Point C. SOI Rollback Verdi/Mogul Traffic

A More Complete Background of Parcels

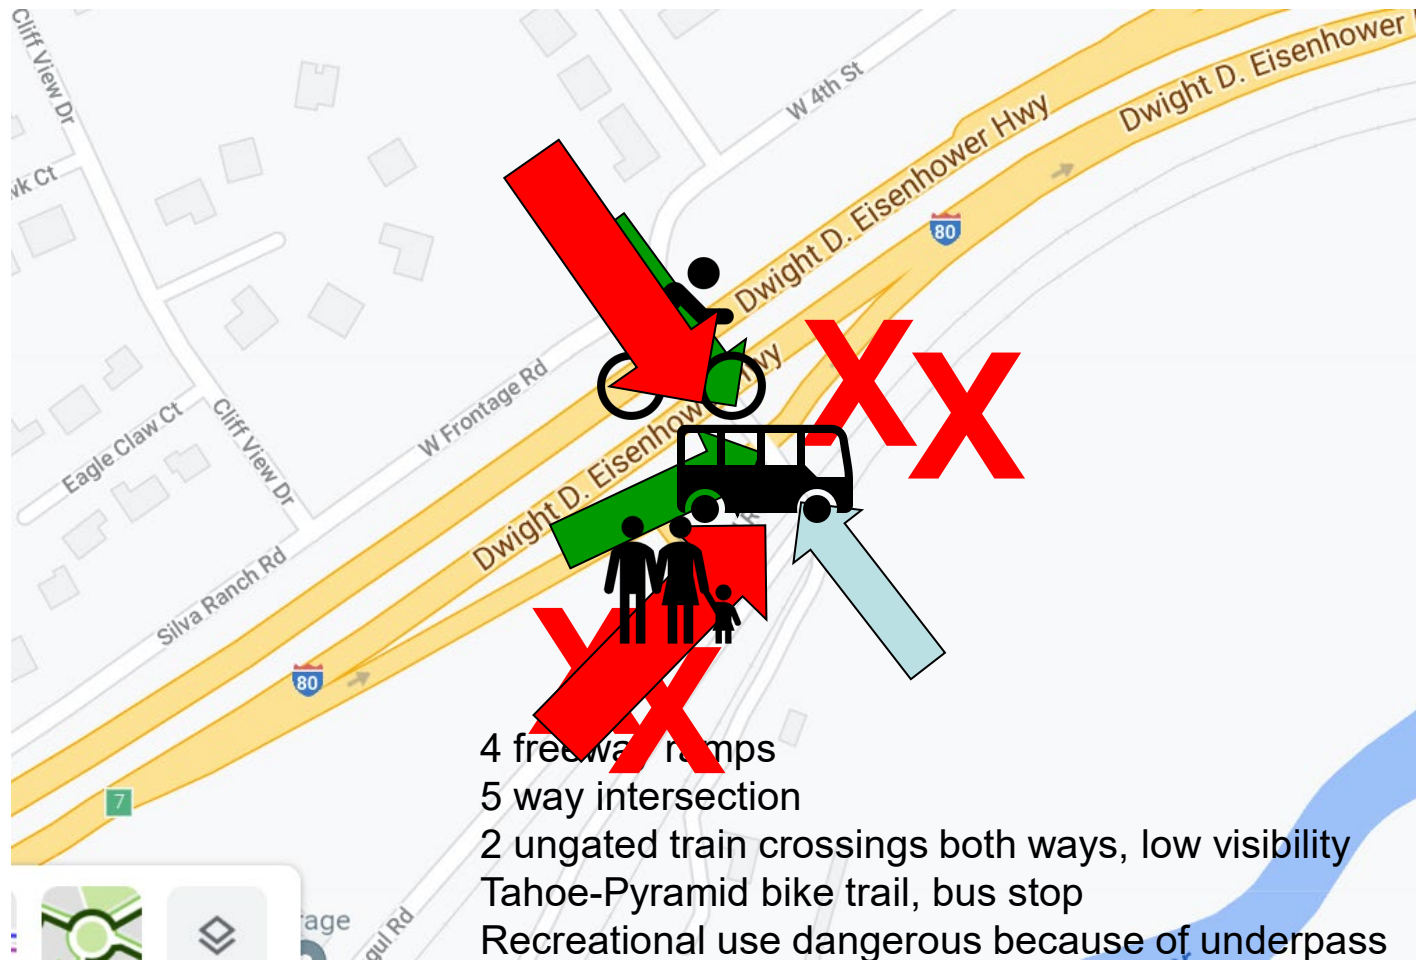
Complex, dangerous and outdated intersection

Bad visibility, trains from both sides

Industrial traffic detrimental

Figure 10-69. Typical Single-Lane Entrance Ramps

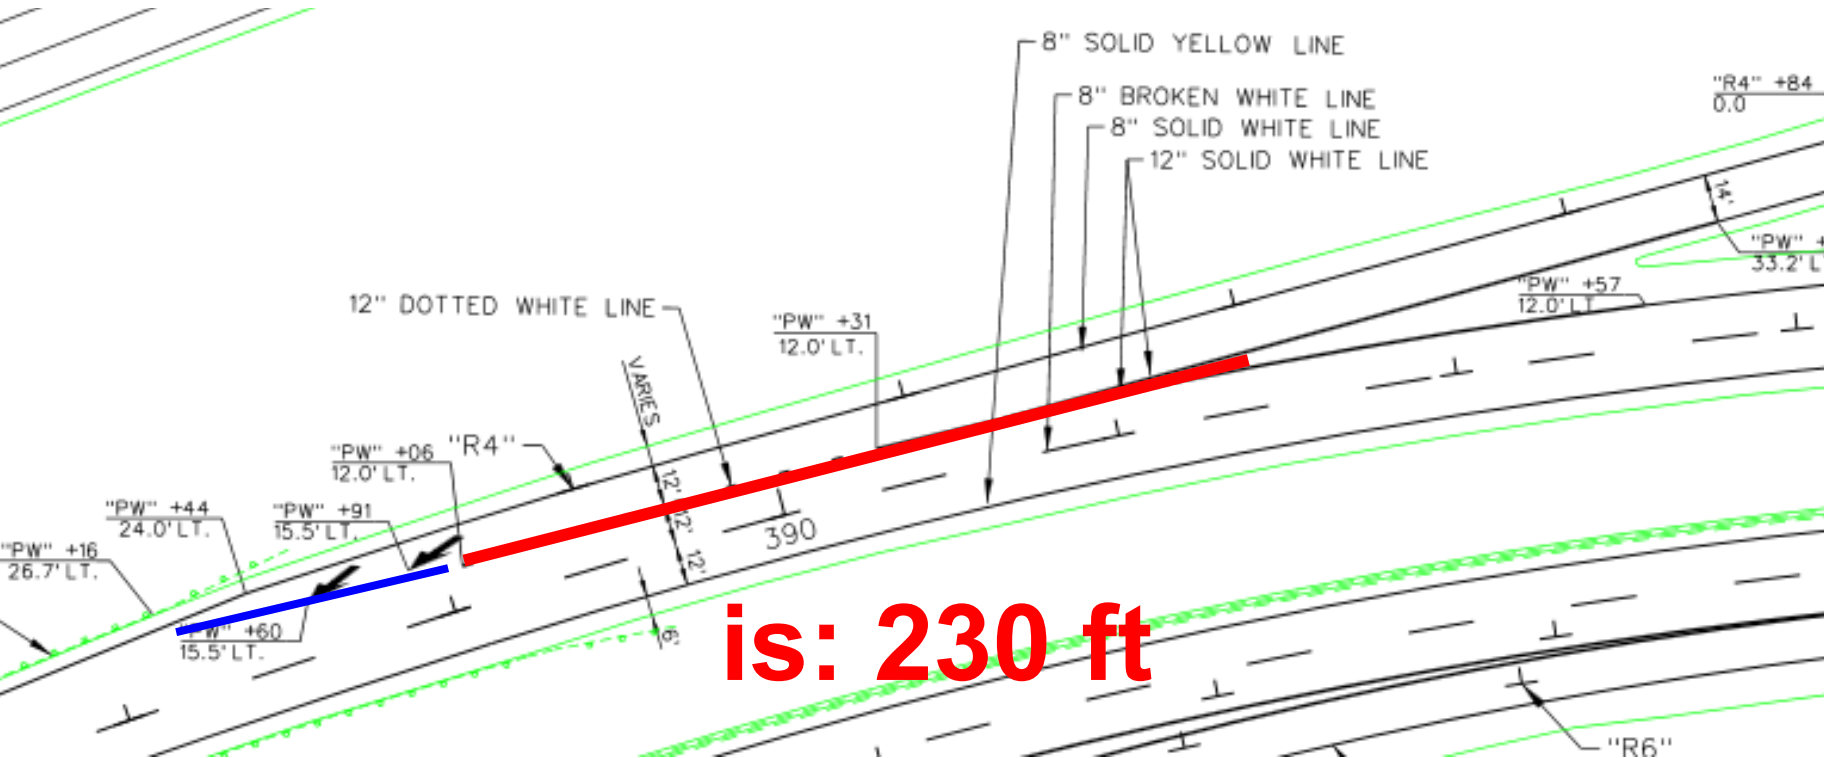
Westbound on-ramp not up to minimal safety standards

is: 230 ft

<300-500 ft requirement

Photo: 10-15-19 at 3 pm

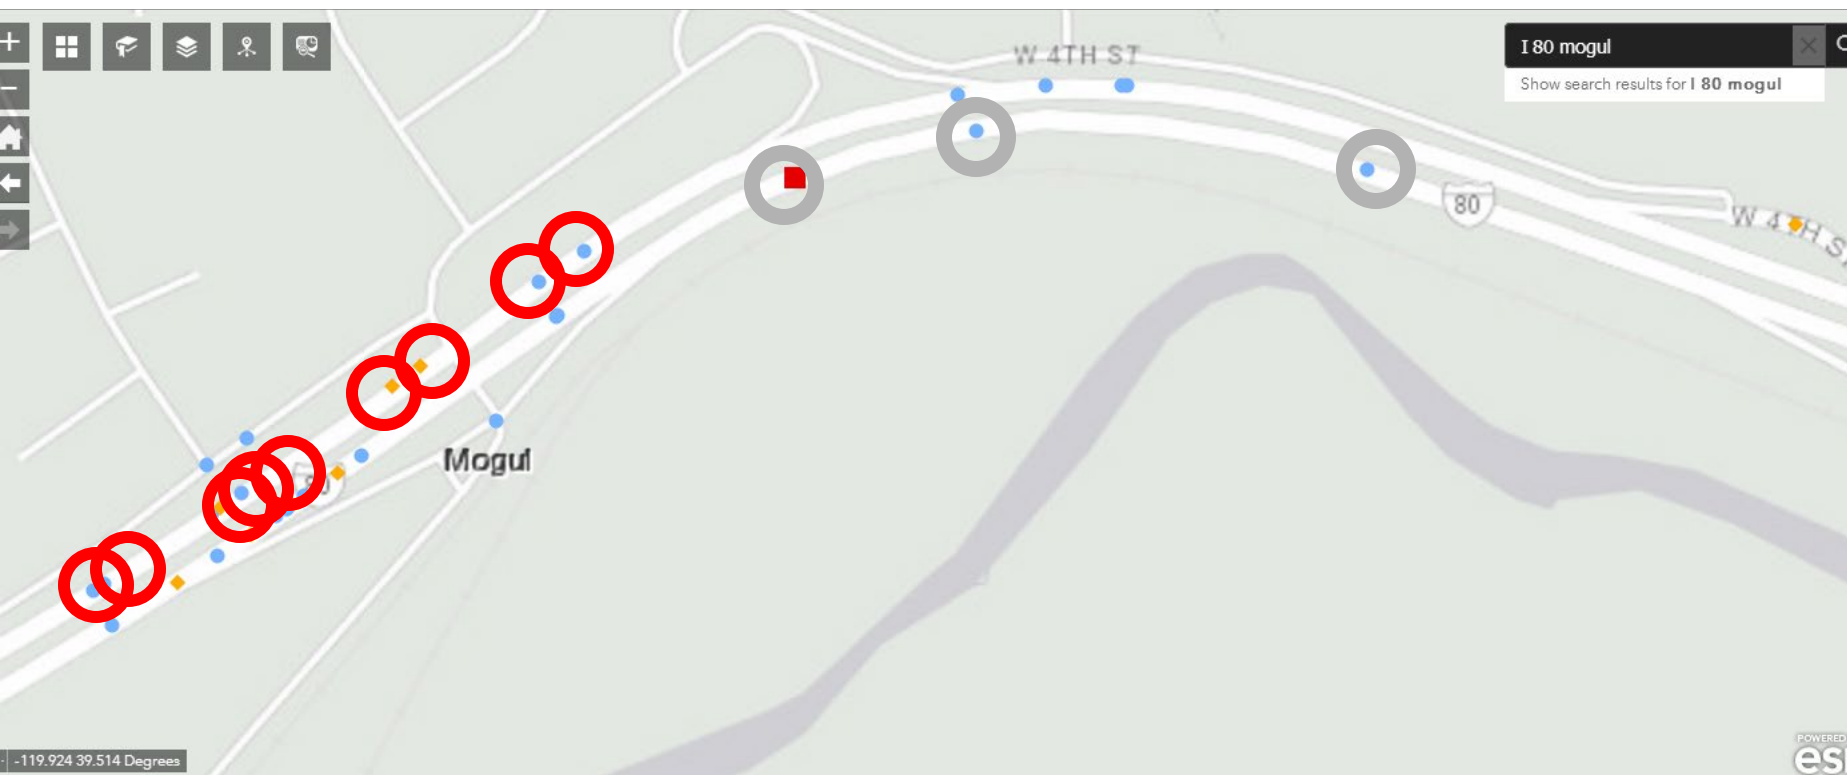
Trucks merging onto I-80 west at 30 mph

Recommended speed: 60 mph

Crash data exit 7 2015-2017

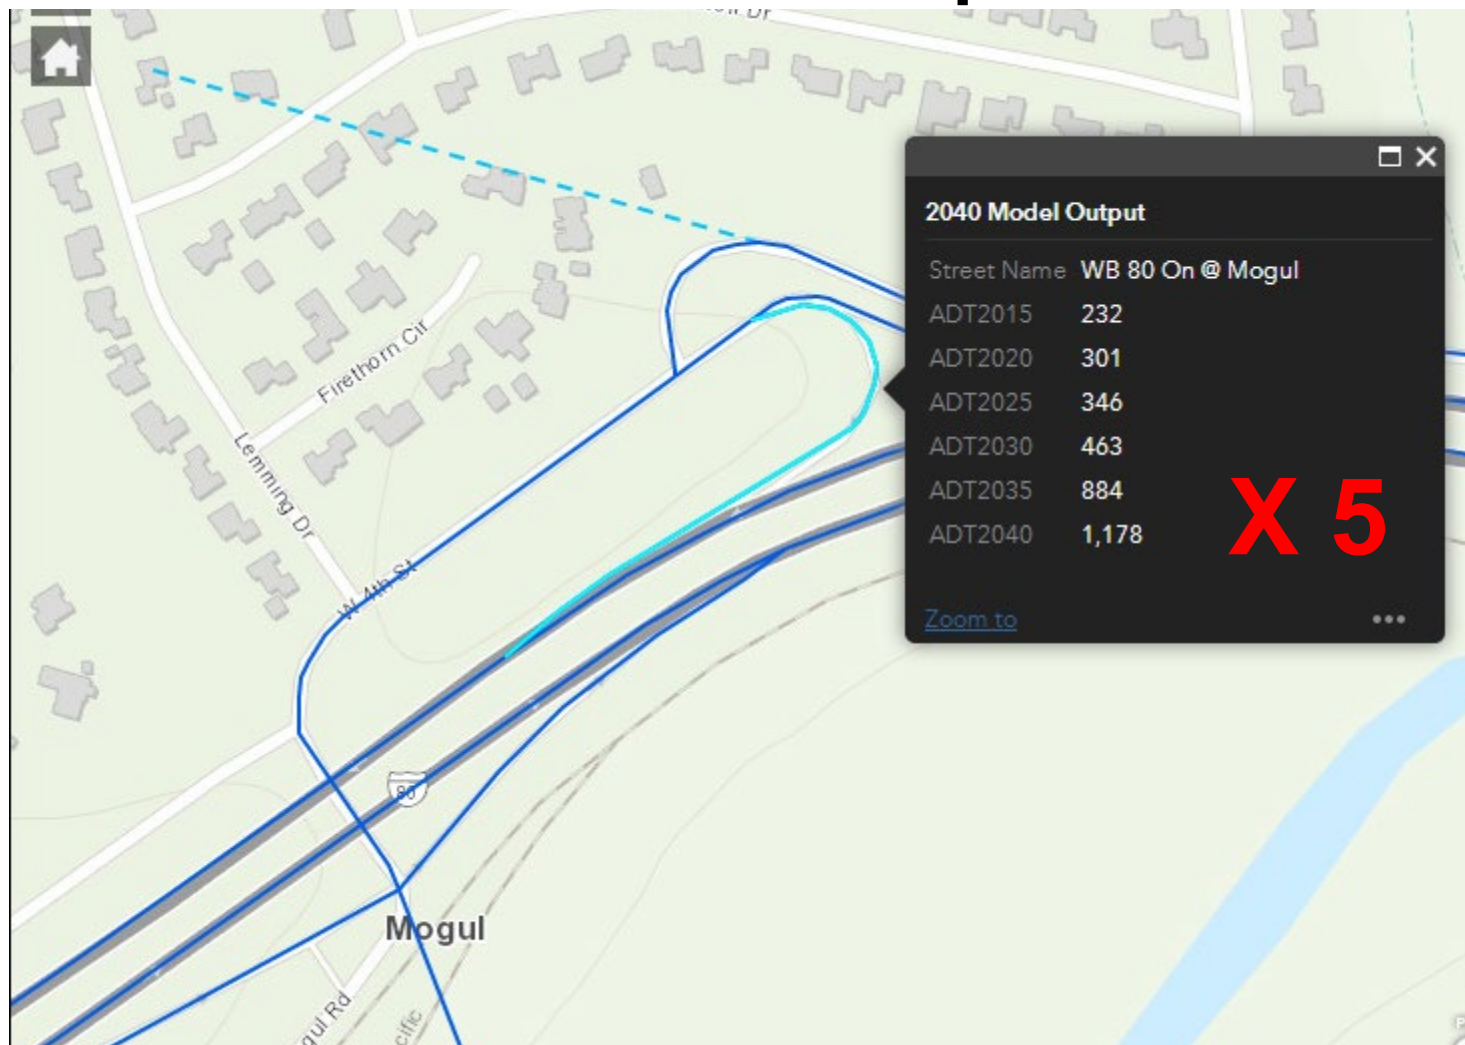
Cluster of crashes around this ramp, 3x more than on the opposite on-ramp
